18-014ARB-DEMO – 113 S. HIGH STREET

Request

Review and approval of a demolition under the provisions of the Zoning Code Section and the *Historic Dublin Design Guidelines*.

C. Proposal

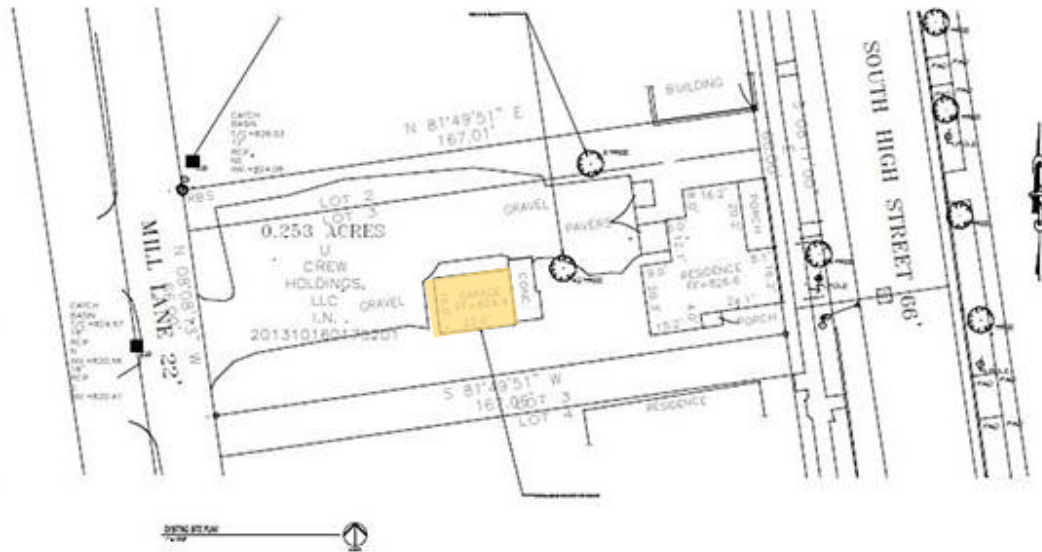
The applicant is proposing to demolish an existing one-story concrete masonry garage structure to the rear of the existing historic building.

Staff: The existing accessory structure is not considered to be a contributing structure in the Historic District and no significant architectural or historic features exist.

Staff: The size and condition of the detached accessory structure is insignificant to have any viable economic use and is not large enough to have a feasible return on the required investment needed to rehabilitate the structure.

Staff: Staff finds the existing detached accessory structure in its location would impede orderly development, and detract from the historic value of the vicinity; and finds the proposed demolition of the accessory structure would not remove a significant historic structure and would not diminish the unique historic character of the surrounding area.

- 1) The order to allow a demolition shall not be issued by the City until a replacement use or building has been approved by the Reviewing Body and an application for building permit has been submitted for the replacement building to the City.
